MFN 06-268

Docket No. 52-010

**Subject: Response to Portion of NRC Request for Additional Information  
Letter No. 43 Related to ESBWR Design Certification Application –  
ESBWR Containment Design and Probabilistic Risk Assessment Re:  
Containment Fragility Analysis – (Release A) RAI Numbers 6.2-95,  
6.2-97, 19.2-41, 19.2-44 to 19.2-46, 19.2-49, 19.2-50 and 19.2-57**

**Partial Response to NRC RAIs 6.2 and 19.2 Release A  
RAI 6.2-95, -97. 19.2-41, -44,-45, -46, -49, -50 and -57**

Figure 19.2-45(1) Locations of the data in PRA Table B.8-1 as indicated in Table 19.2-45(3). Upper Drywell and Wetwell.

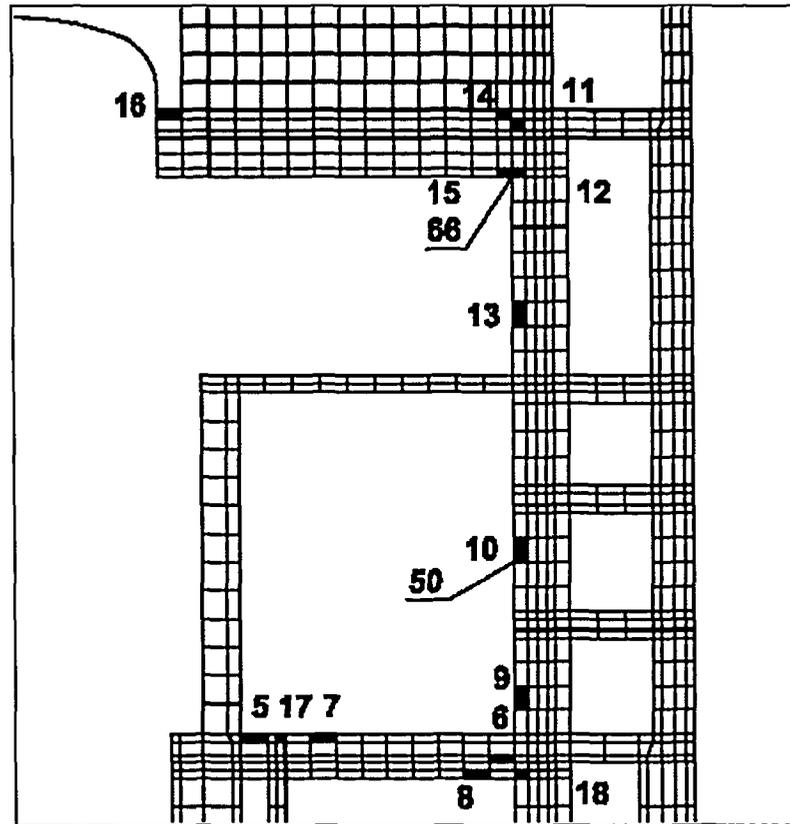
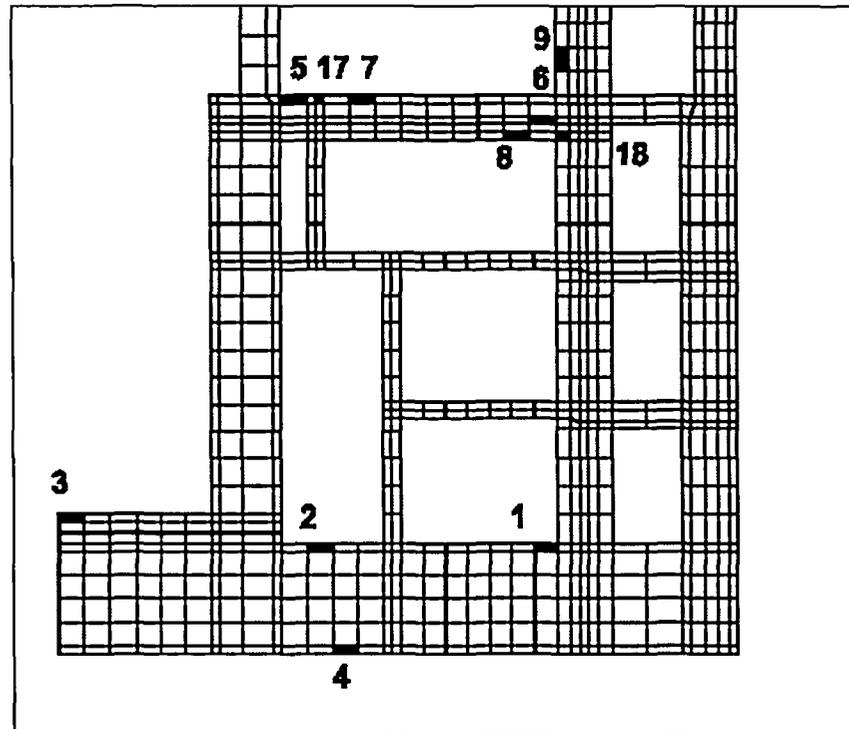
- d) Provide the max. rebar strains (including locations) at each pressure level for all components in Table B.8-1, and provide a discussion of comparisons of max. rebar strains with the max. liner strains listed in Table 8.1-1.*

- f) What is the radius at the location of the reported "Max. Radial Defl. Wetwell", and what are the calculated strains at this location (i.e., radial deflection divided by radius)? Compare to the rebar strains.*

- d) Table 19.2-45(2) and 19.2-45(3) show the maximum rebar strain at each pressure level for all components in Table B.8-1. as well as their locations. See response to RAI 6.2-95 for a detailed comparison of rebar strains and liner strains at 1.468 MPa.

- f) The reported Max. Radial Deflection, is the maximum radial displacement in any point of the containment. In this case it is measured in the middle of the wetwell and is 13.02 mm. For a 18,000 mm inside radius of the containment, radial strain is 0.072%. Radial strain for the rebars in the same location is 0.017% (point 50 in Figure 19.2-45(1)) which is the same order.

**Figure 19.2-57(1). Drywell Temperature History for 80 cm Diameter Breach of RPV**

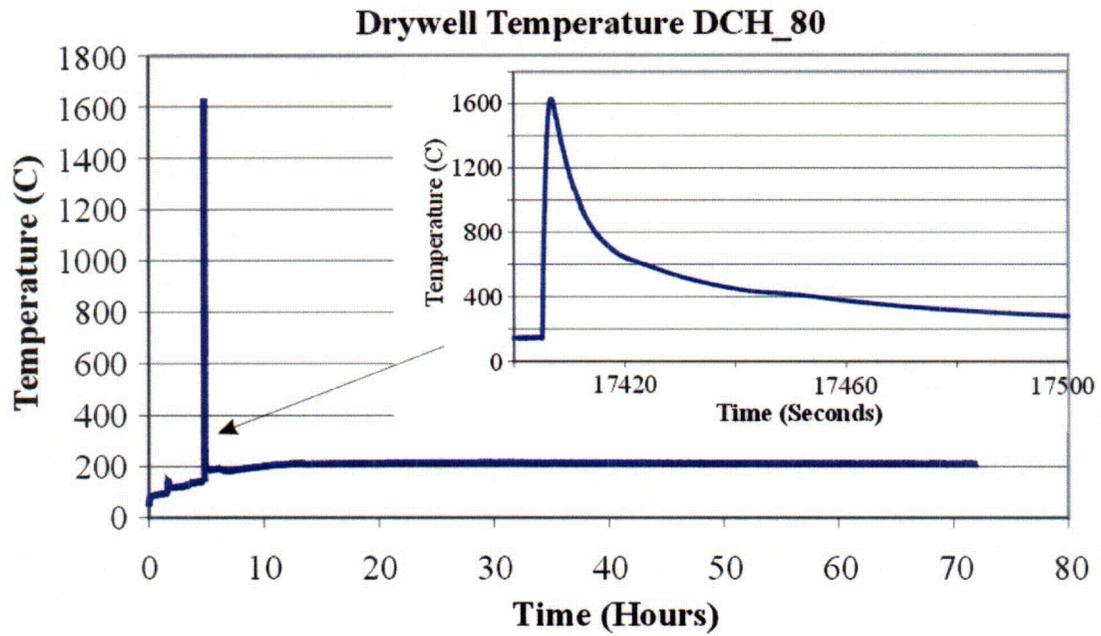
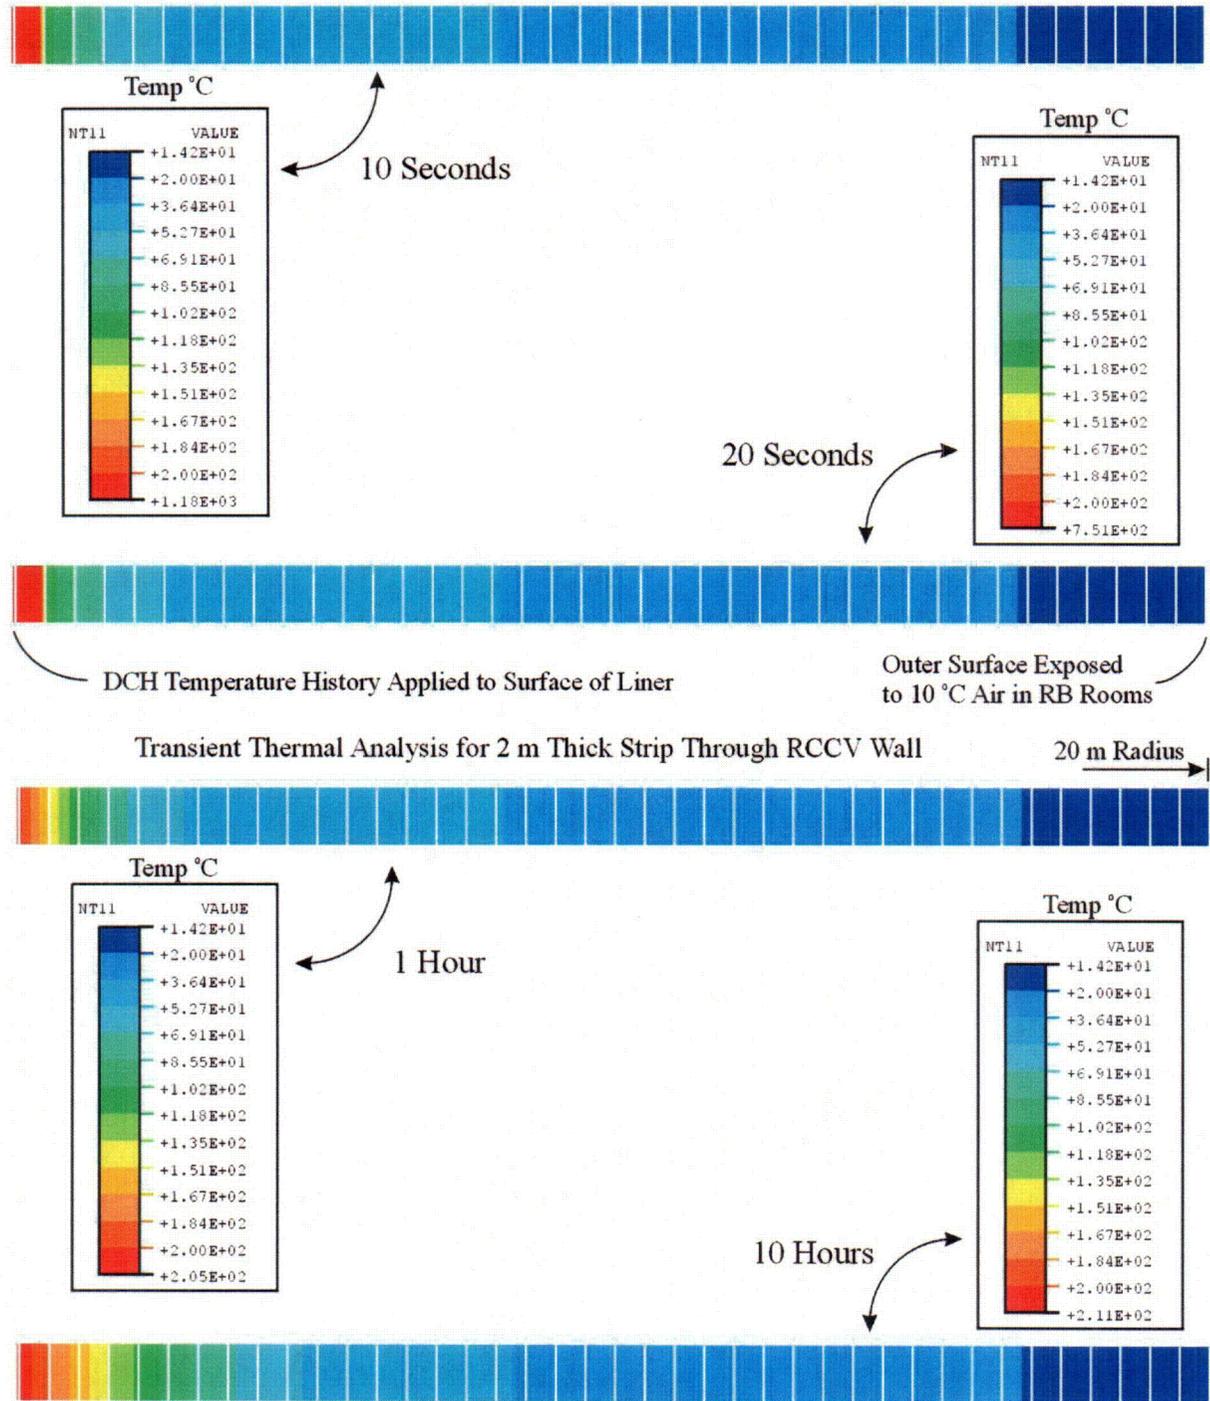
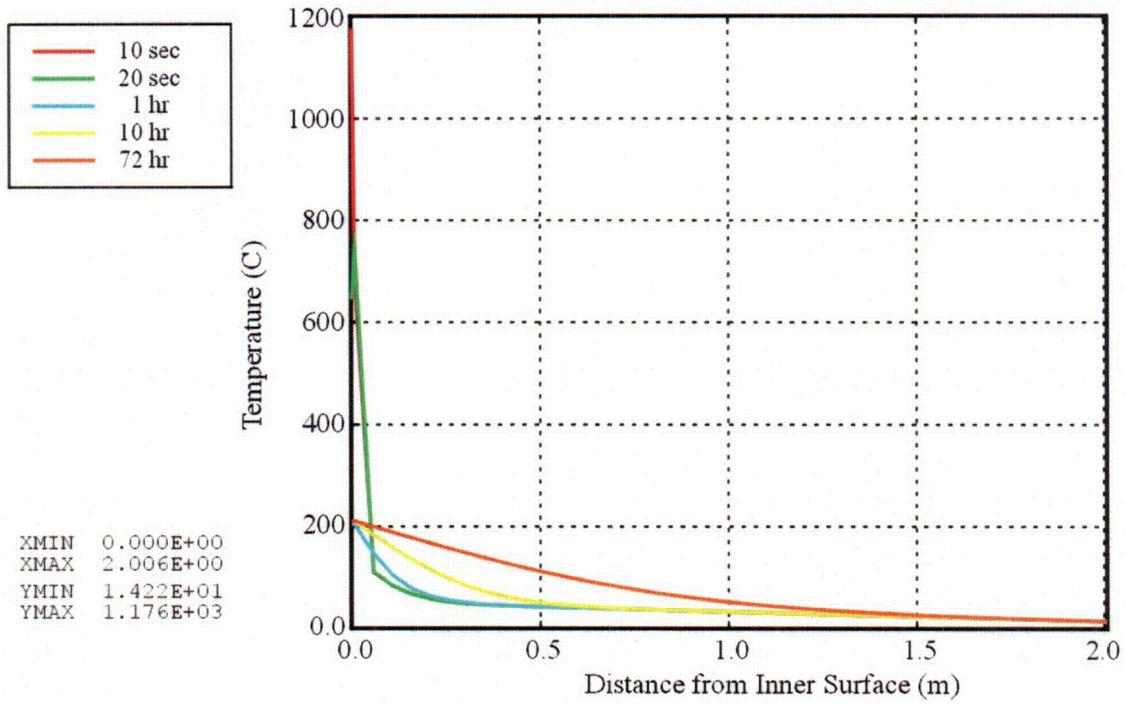
- a) a discussion of the duration of concrete exposure to high temperatures, and the depth of thickness of the concrete which will degrade due to exposure to high temperatures.*
- b) information and a discussion of available test data that supports the GE analysis regarding the concrete performance at high temperatures.*

- a) Calculations were carried out with the MAAP code to determine the long-term temperature history of the upper drywell atmosphere under the assumption that the PCCS and BiMAC systems were functional. We considered a bounding case as found in Section 21 of NEDO-33201 Rev 1 analysis of the DCH event, and we made sure that the starting point of this long-term, systems analysis matched the post-DCH temperature levels found in the DCH event assessment of Section 21 of NEDO-33201 Rev 1. The result is shown in Figure 19.2-57(1). Note as a result of the cooling systems the DCH-induced high temperature spike is just that; in other words it is seen to dissipate in a matter of a few seconds, reaching down to less than 3000 C in ~1 minute. From then on the temperatures decay slowly down to 2000 C in less than 1 hour where it seems to stabilize for the long term (72 hours and beyond).

We then proceeded to find an upper bound heat up of the concrete by imposing this temperature history on the inner surface of the liner (that is assuming an infinite heat transfer coefficient) along with a gap conductance that was kept conservatively low for the duration of the transient. The results are summarized in Figure 19.2-57(2) and Figure 19.2-57(3). First it is interesting to note that the atmospheric spike attenuates already by the liner, with a peak of only 8000 C. Then we note that the combined effect of slow conduction into the concrete along with the rapid cooling of the atmosphere yields a very slow penetration of a thermal wave whose peak value on the surface is just under 2000 C.

- b) We can easily see that the effect of this kind of concrete heating is negligible, both in terms of the amount of material involved as well as in terms of the level of temperatures reached (see Ref 1).
